**DUKE POWER COMPANY
NUCLEAR GENERATION DEPARTMENT**

**ODCM
OFFSITE DOSE CALCULATION
MANUAL**

Subject: Offsite Dose Calculation Manual (ODCM)
Generic Section - Revision 43

Figure B5.0-1
 (2 of 2)
 Revision 38
 1/1/97

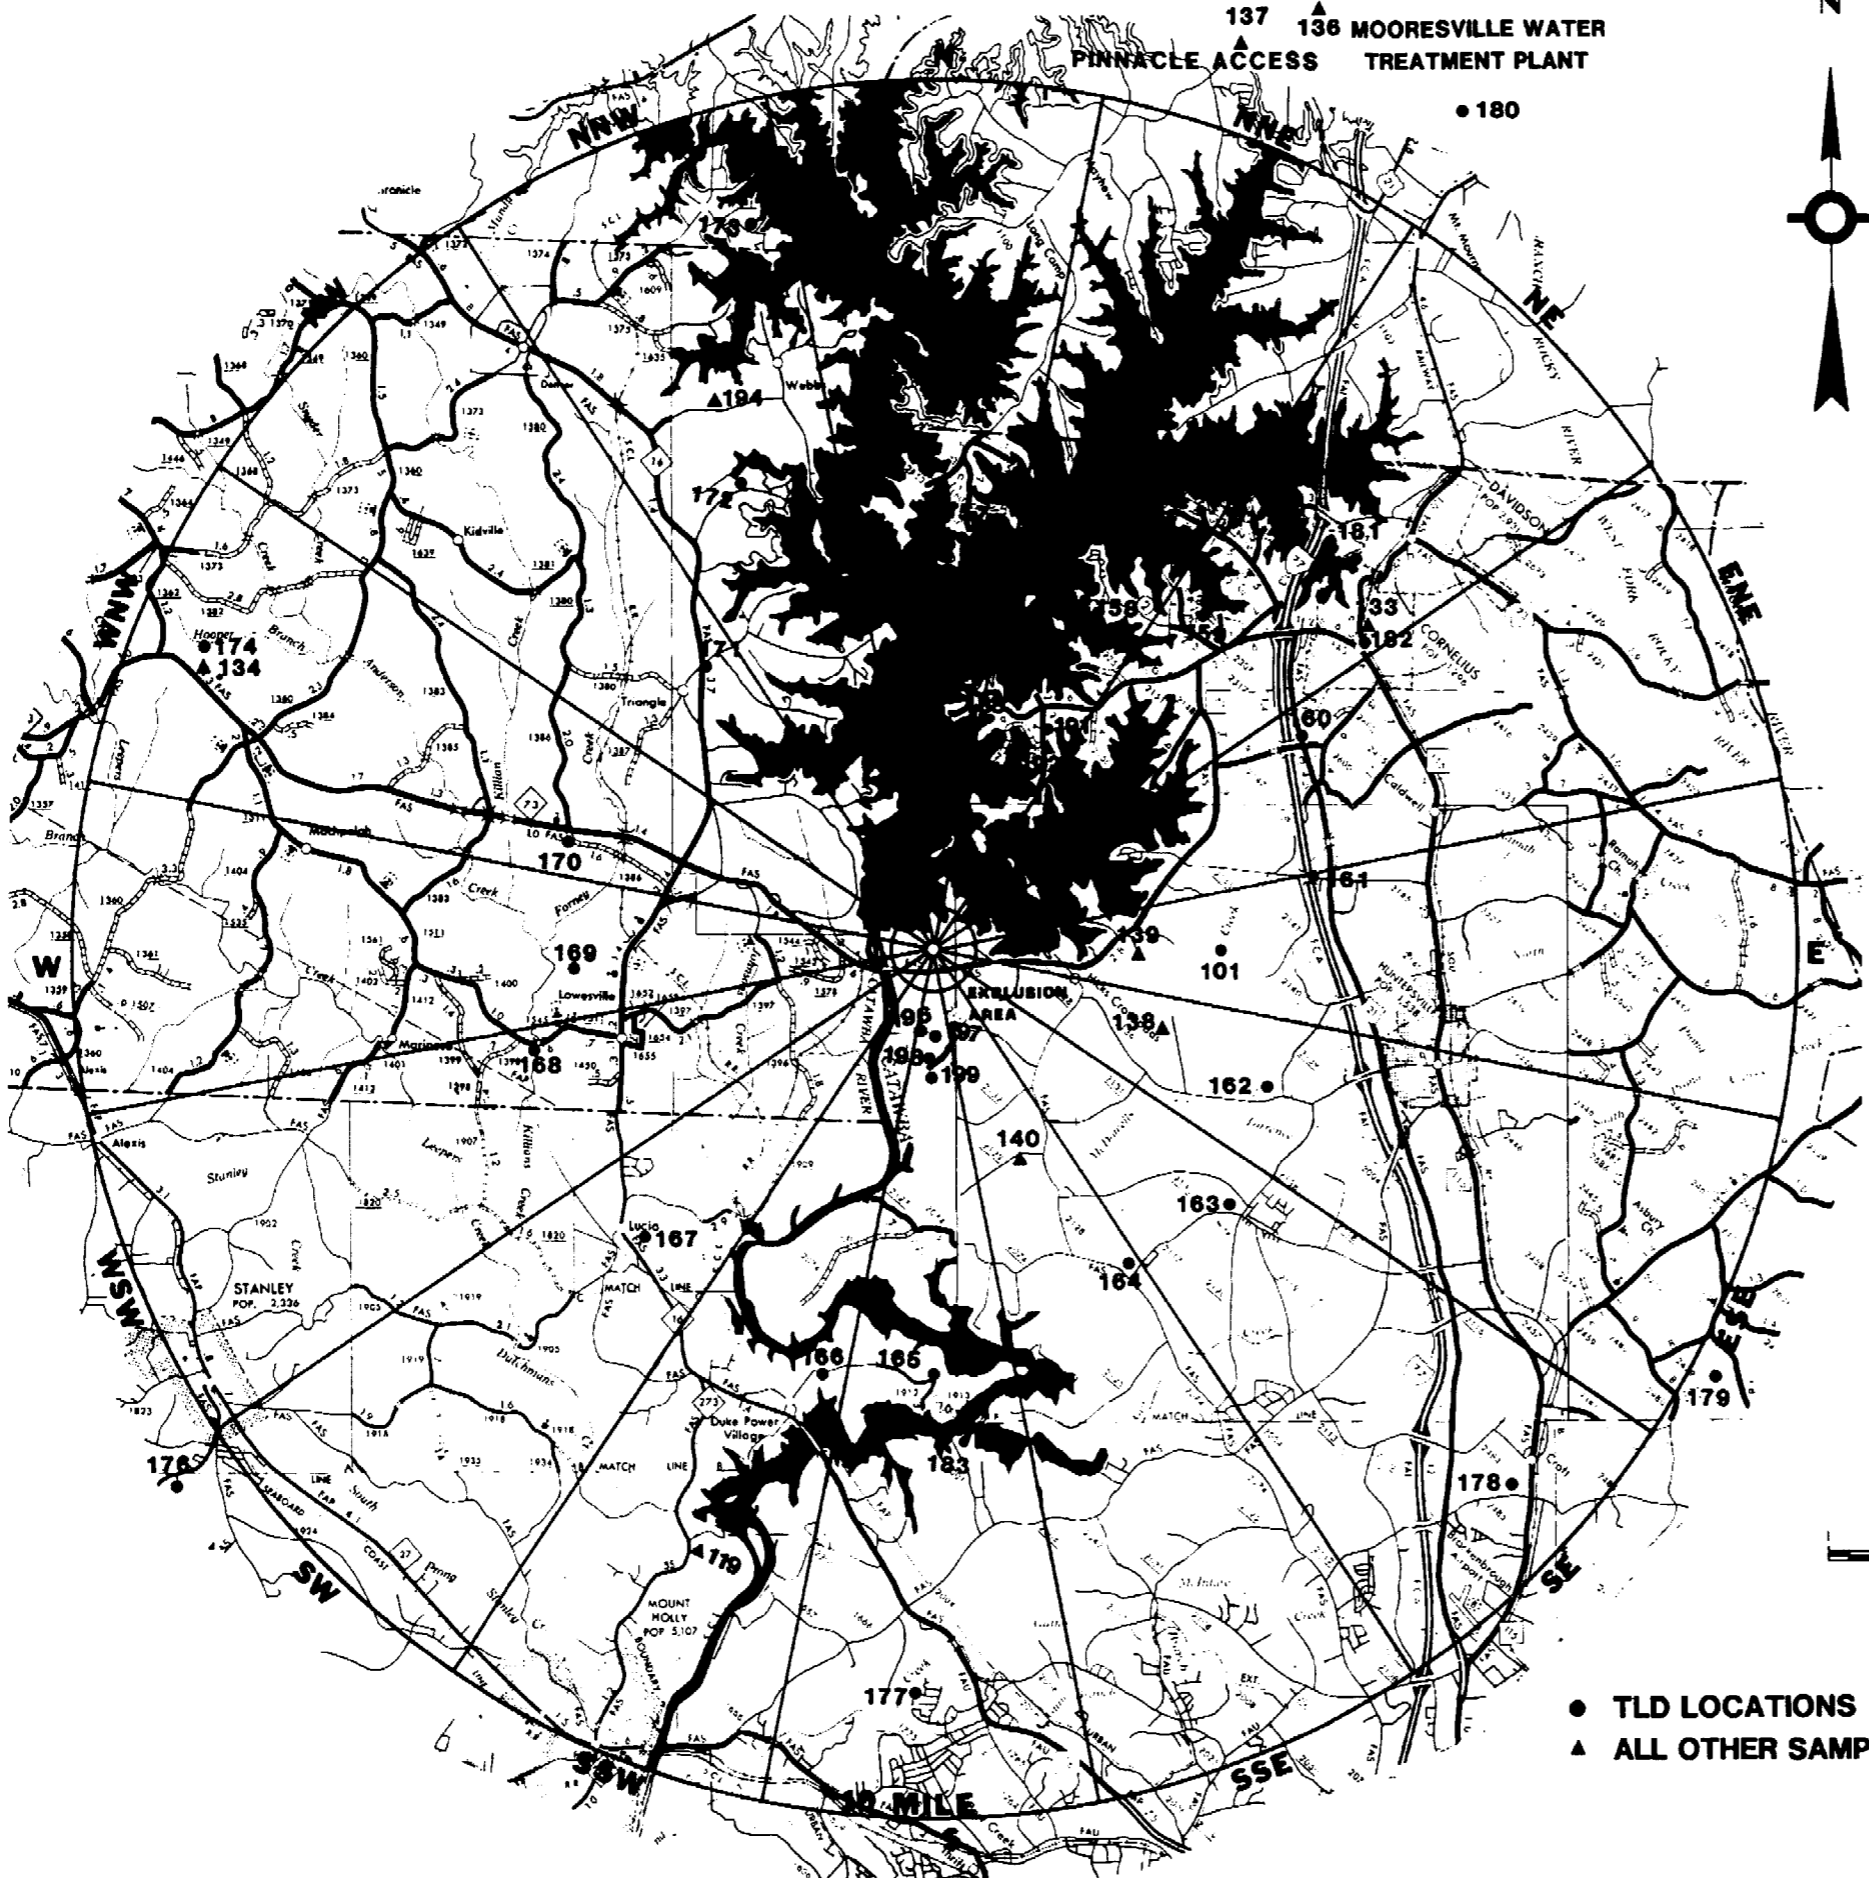
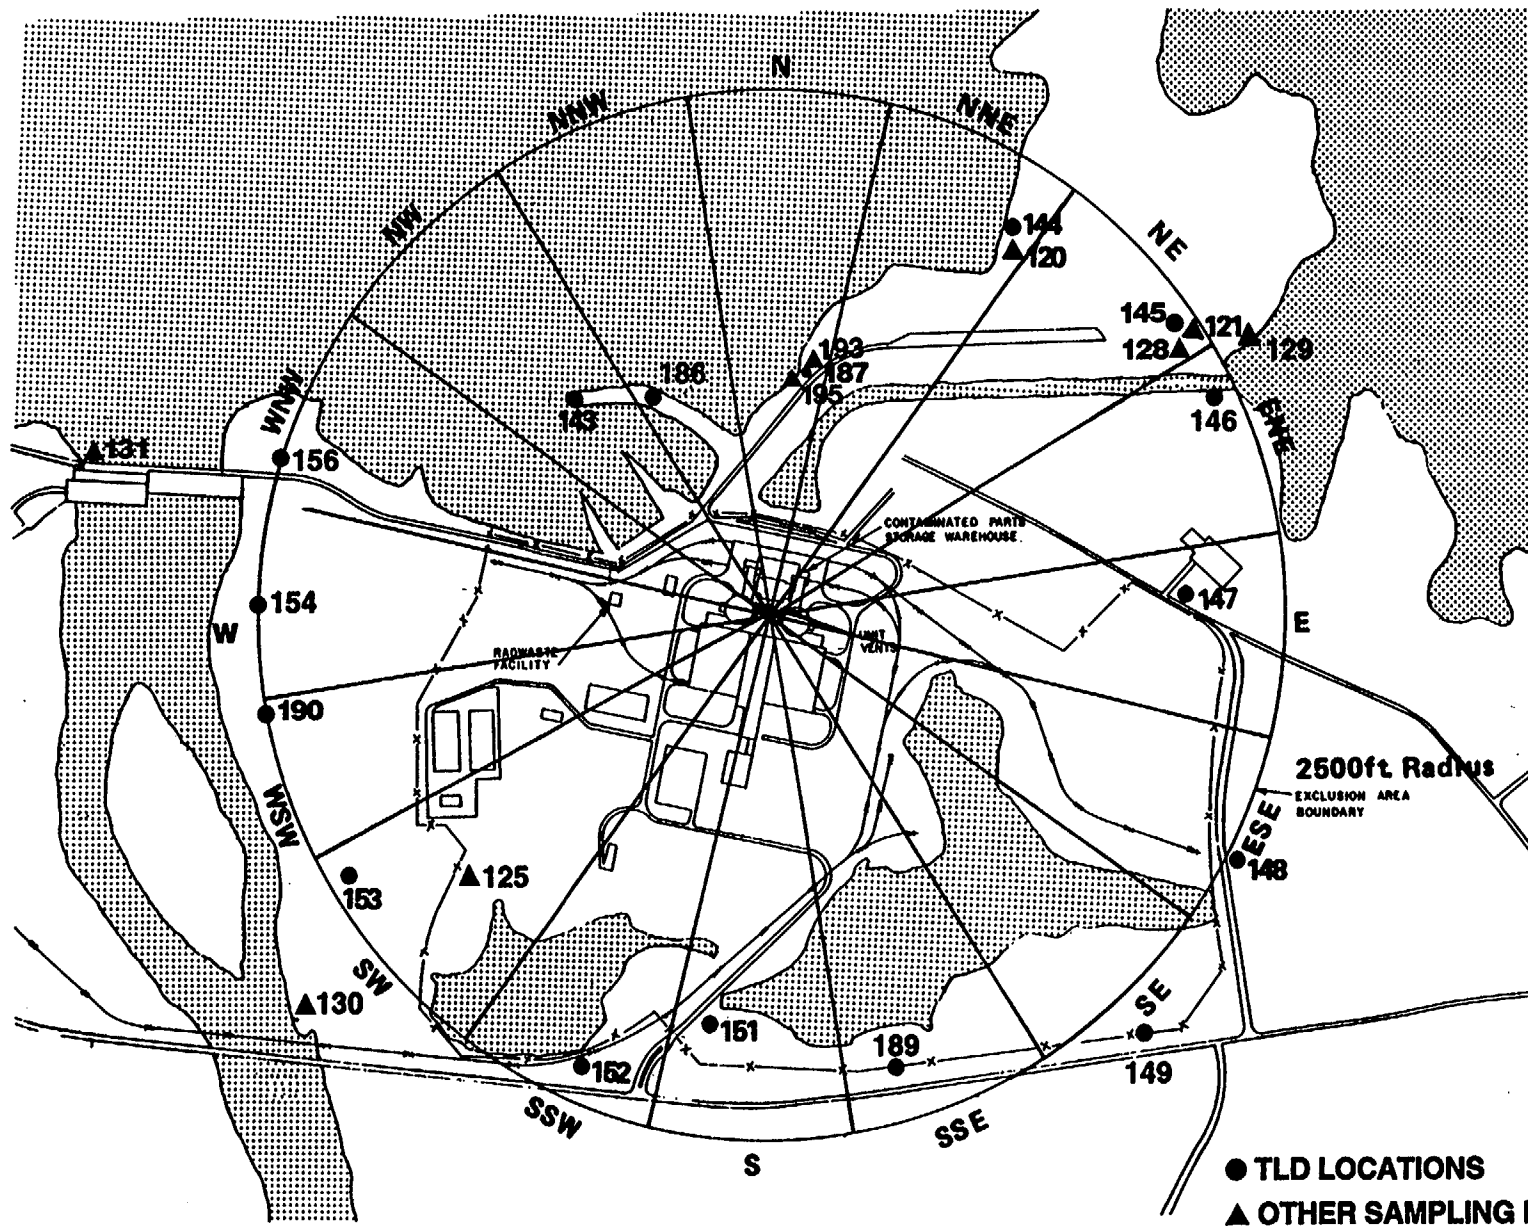
Added North Mecklenburg Drinking Water Site #101.

FIGURE C1.0-1 REV 42 1/1/00
 CATAWBA NUCLEAR STATION
 LIQUID RADWASTE SYSTEM

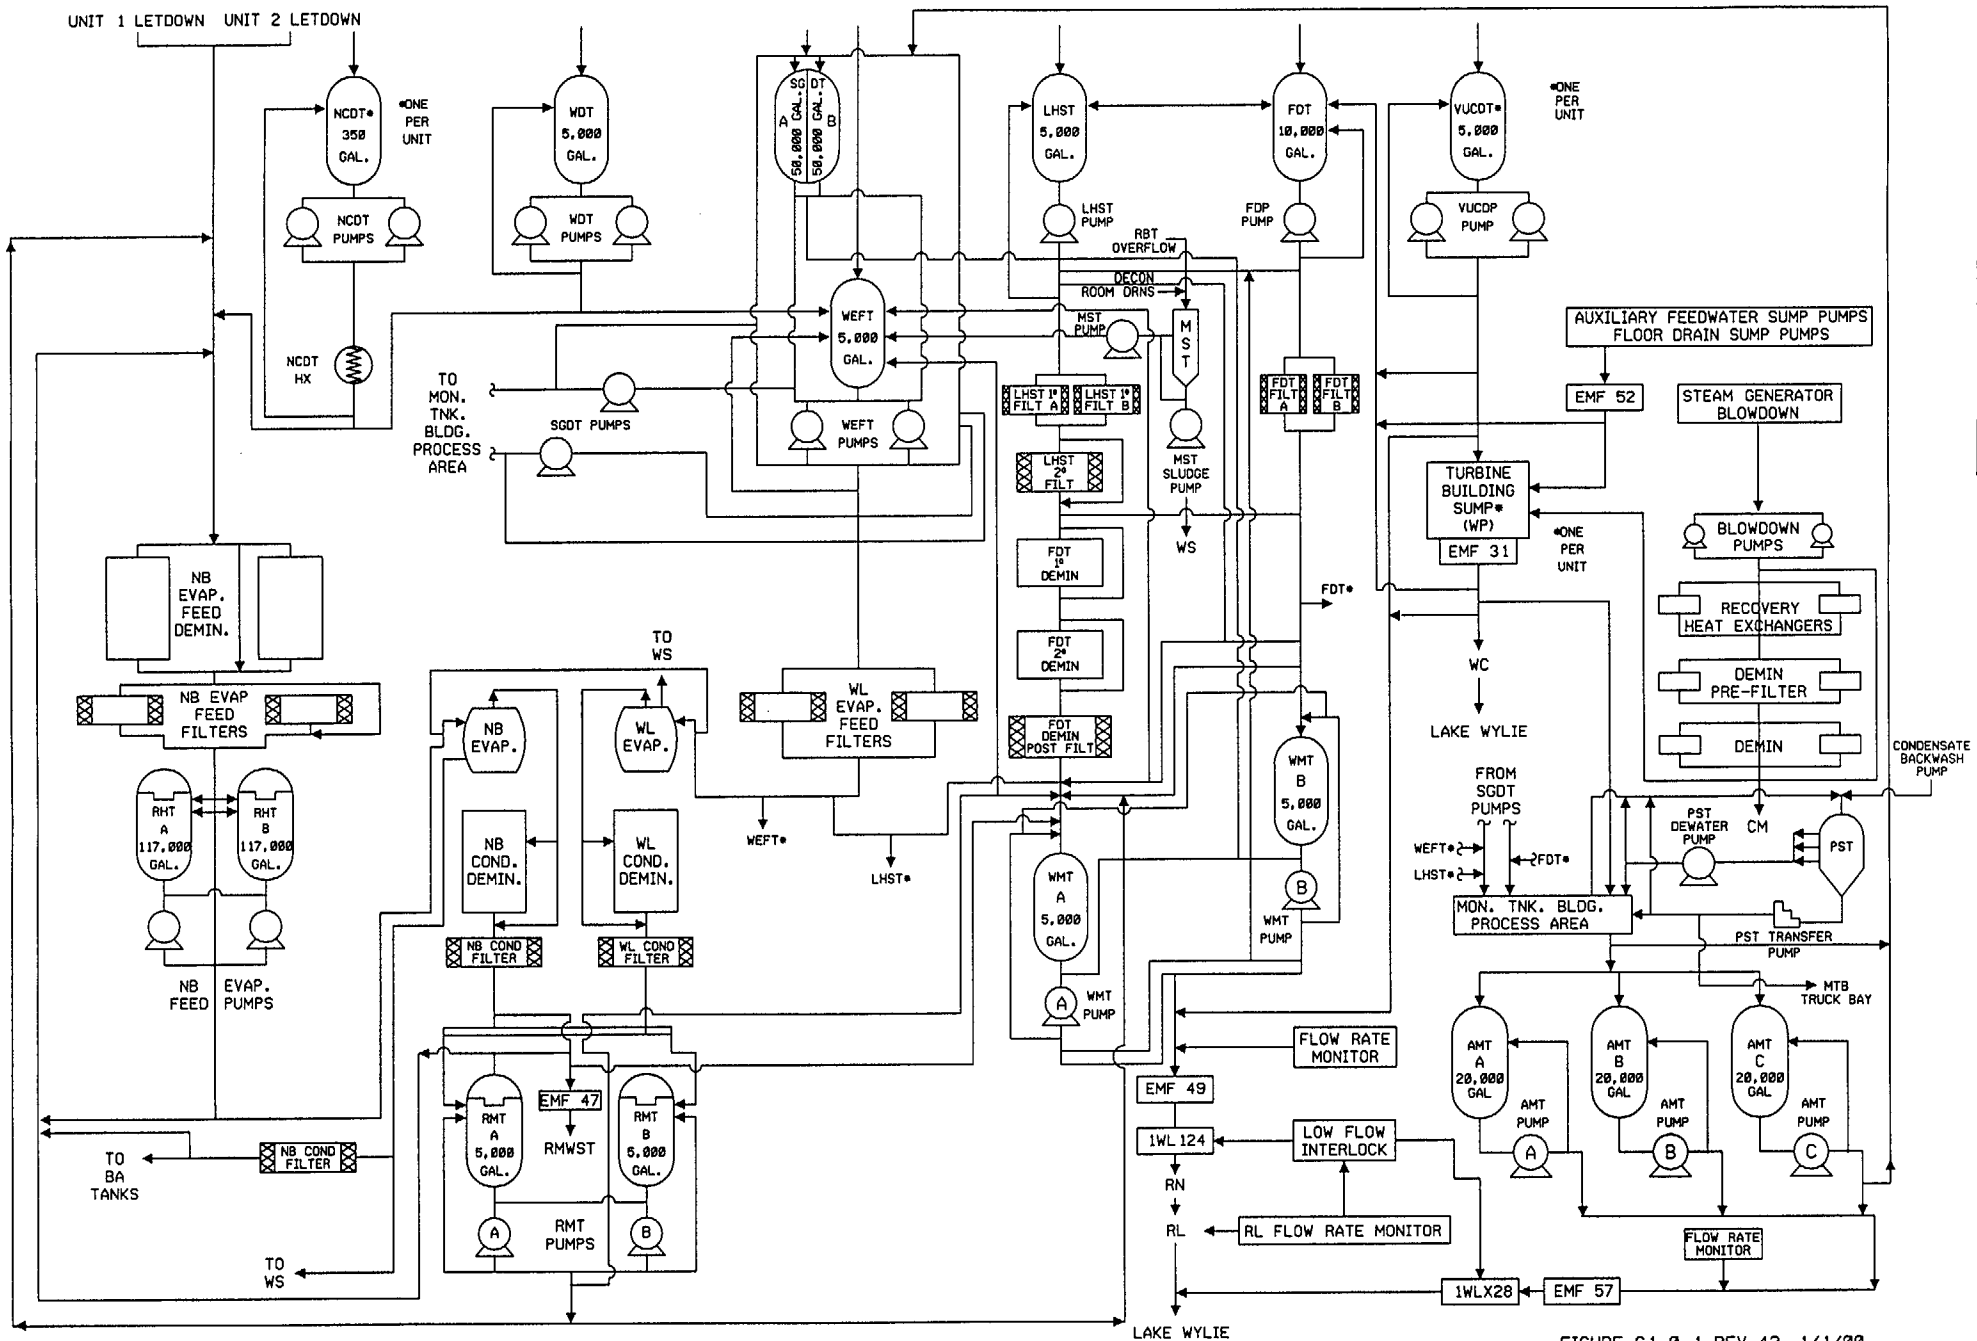
Removed EMF 44 and EMF 34 from the figure. The monitors are no longer used for any process control functions.

FIGURE C1.0-2
CATAWBA NUCLEAR STATION
GASEOUS RADWASTE SYSTEM
PAGE 1 OF 2

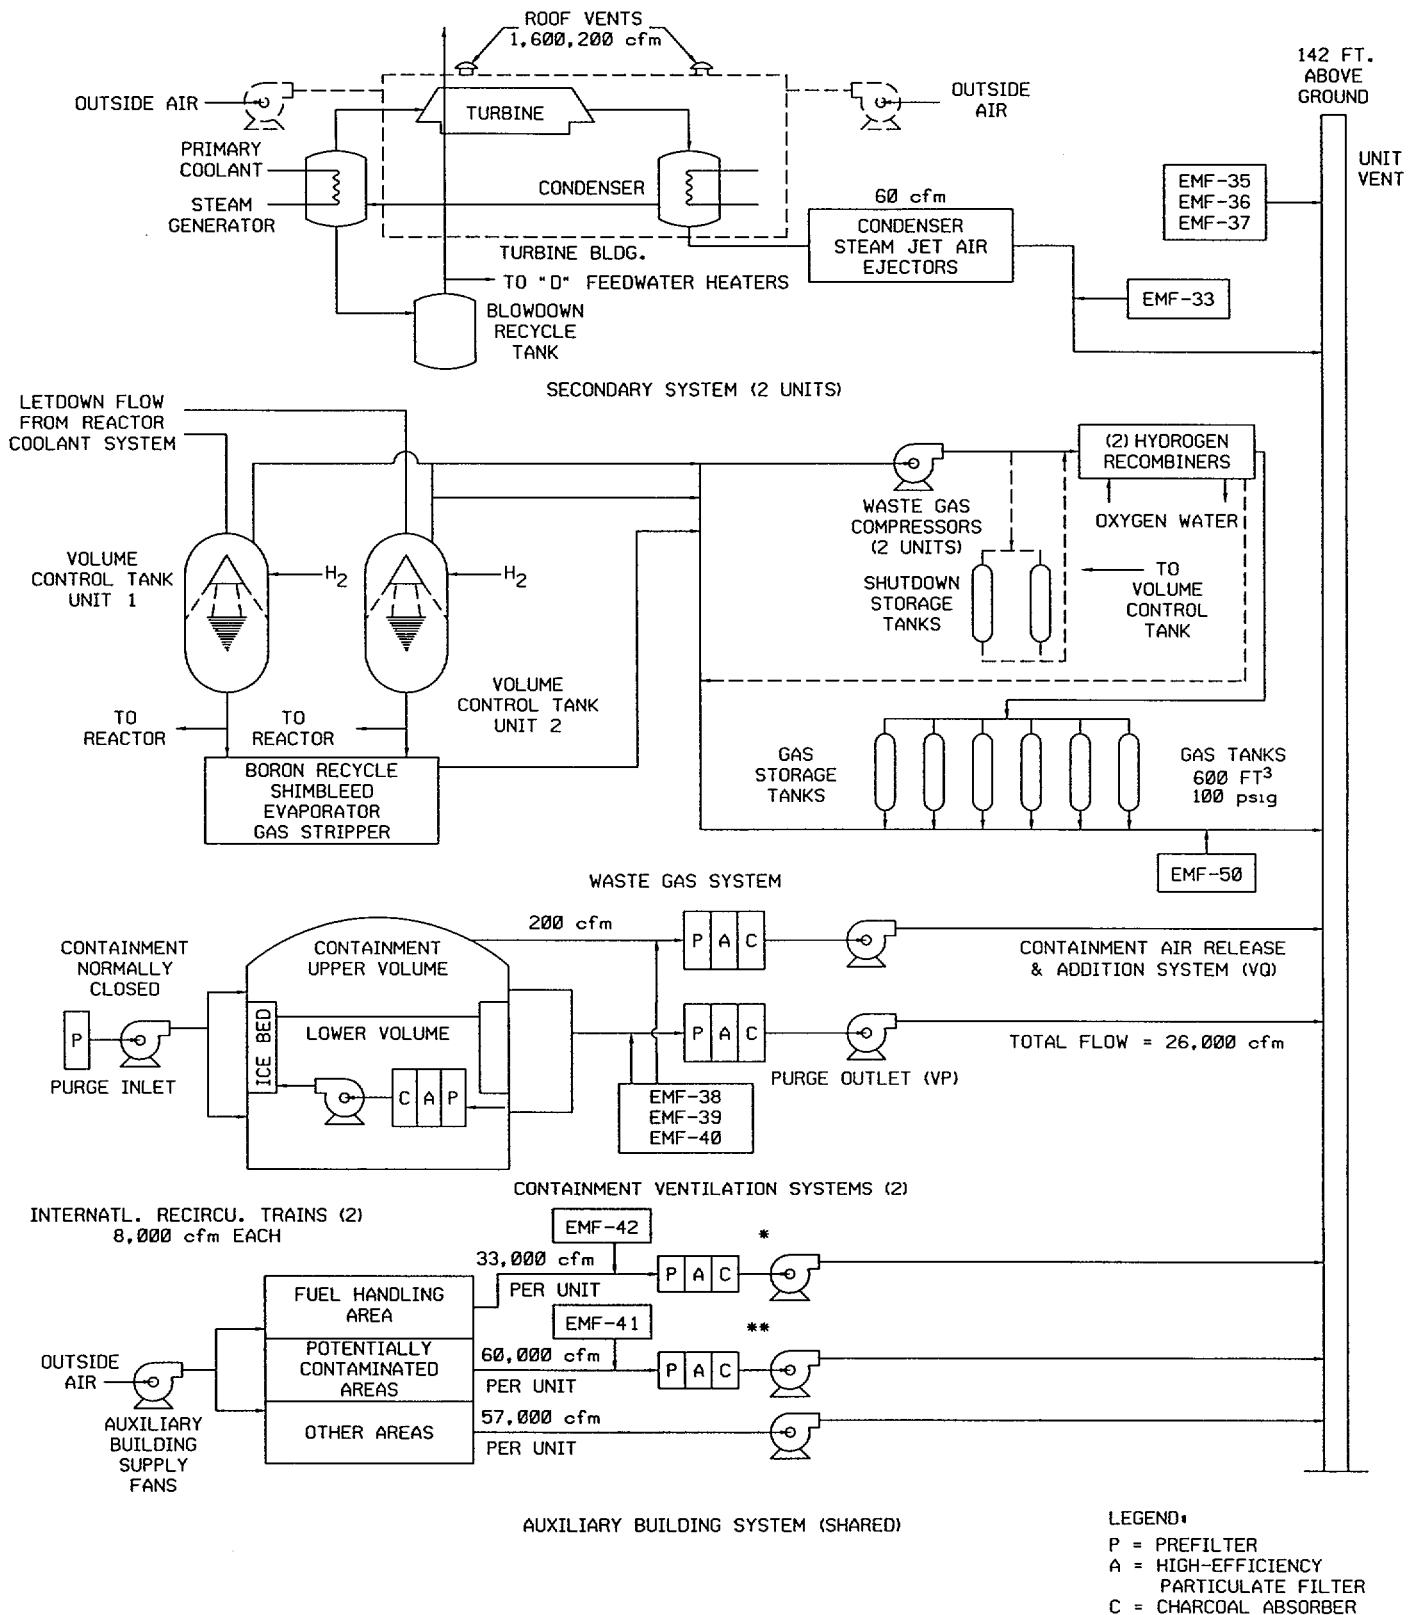
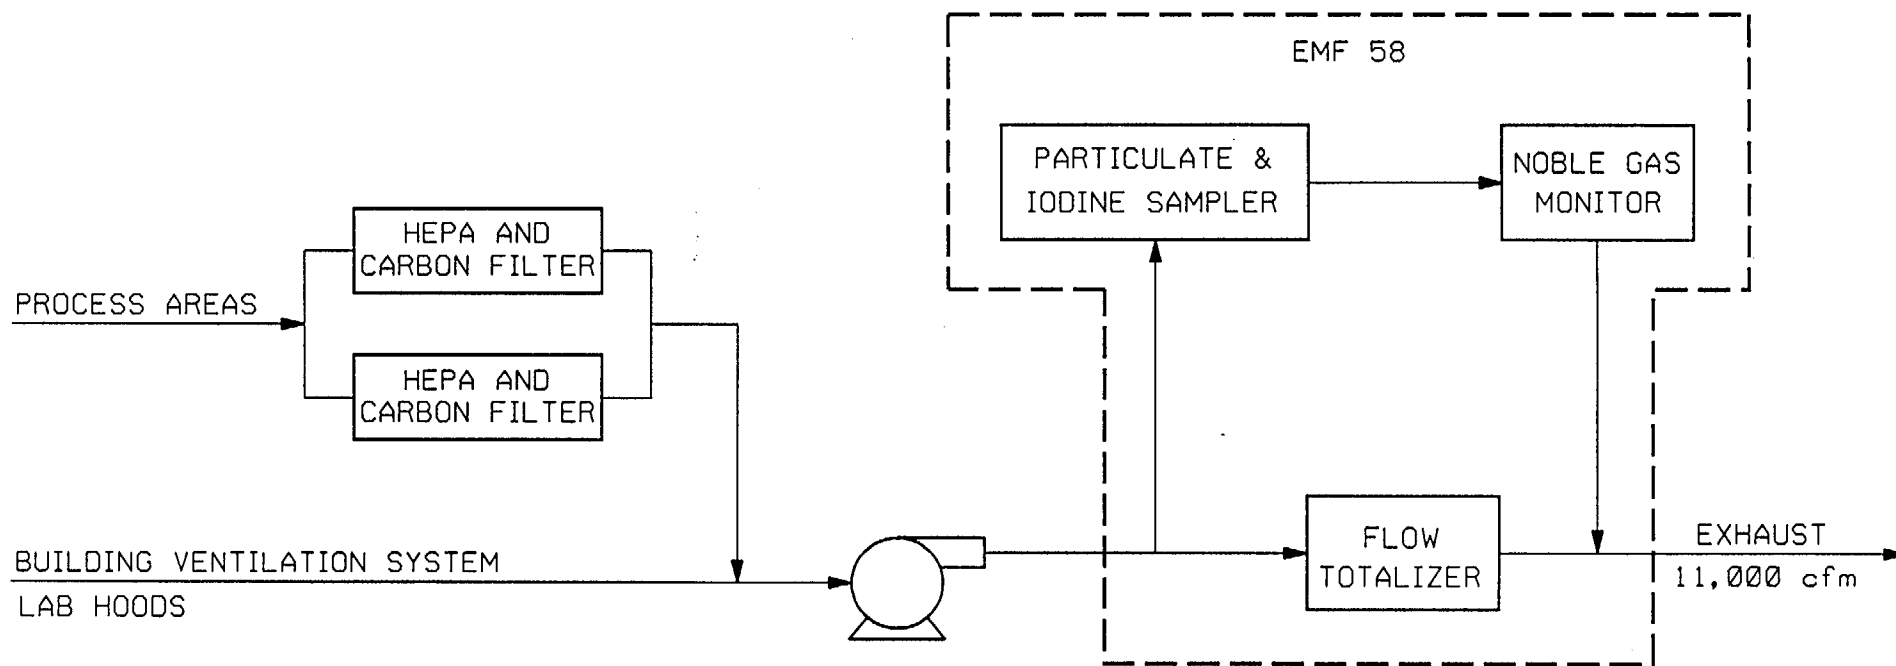
Removed EMF 34 from the figure.
